CASE SUMMARY
Design Adjustment Committee
DAC-5-1024

Design Adjustment
October 16, 2024

<i>Address</i>	8055 Masonboro Sound Road	
<i>Acreage</i>	Approximately 10.09 acres	
<i>Request</i>	Request for a design adjustment for the minimum standards for a minor street.	
<i>Consultants/ Agents</i>	Austin Scheib Hanover Design Services, PA 1123 Floral Parkway Wilmington, NC 28403	(910) 343-8002 ascheib@hdsilm.com
<i>Property Owner</i>	8055 Masonboro, L.L.C. 6316 Marywood Drive Wilmington, NC 28409	(910) 279-3365 pckratsa@gmail.com
<i>Pre-TRC Review</i>	October 6, 2022 & April 6, 2023	
<i>Formal TRC Review</i>	March 28, 2024	
<i>Construction Release</i>	September 13, 2024	
<i>Design Adjustment Committee Action</i>	October 16, 2024; Scheduled for Evidentiary Hearing

Figure 2. Proposed Right-of-Way Improvement Area (Attachment 4)

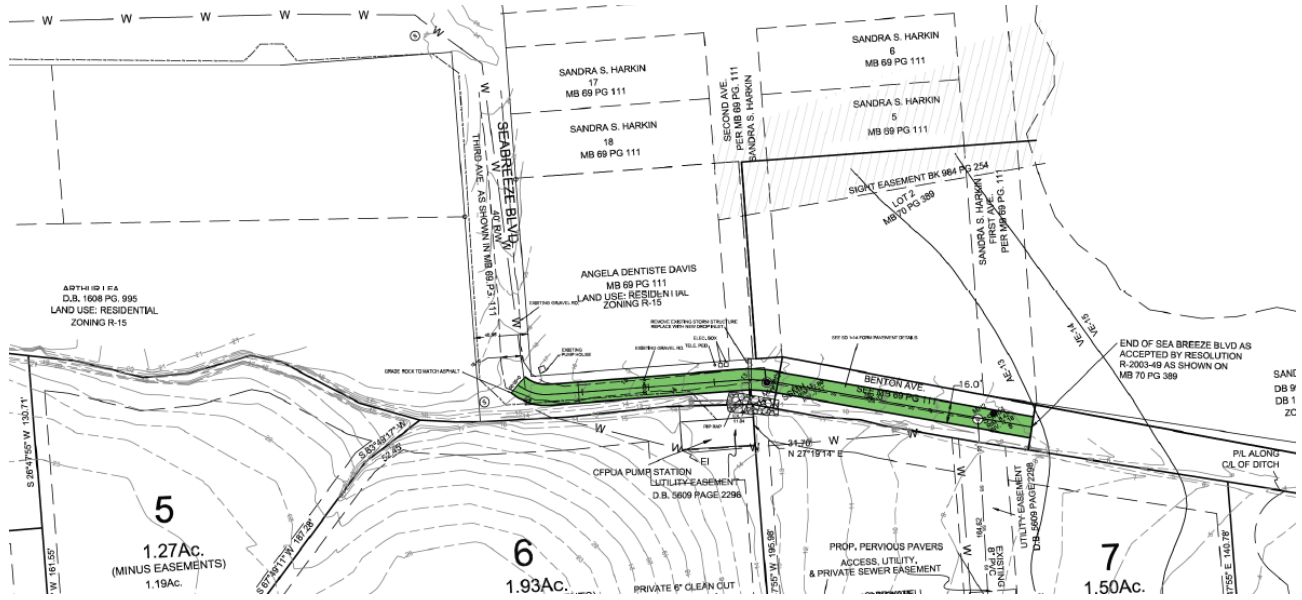
6. Seabreeze Boulevard adjacent to the site is required to be improved to City standards based on the code section referenced above.
7. The proposal includes the construction of a minor street with a non-standard cross-section, which includes grading, ABC stone, and stormwater infrastructure.

8. The Technical Standards & Specifications Manual (TSSM) specifies a standard cross-section for a local street. The applicant proposes a non-standard cross-section that includes the following modifications:

- The installation of 8" of compacted ABC stone, grading, and stormwater drainage improvements within the right-of-way.
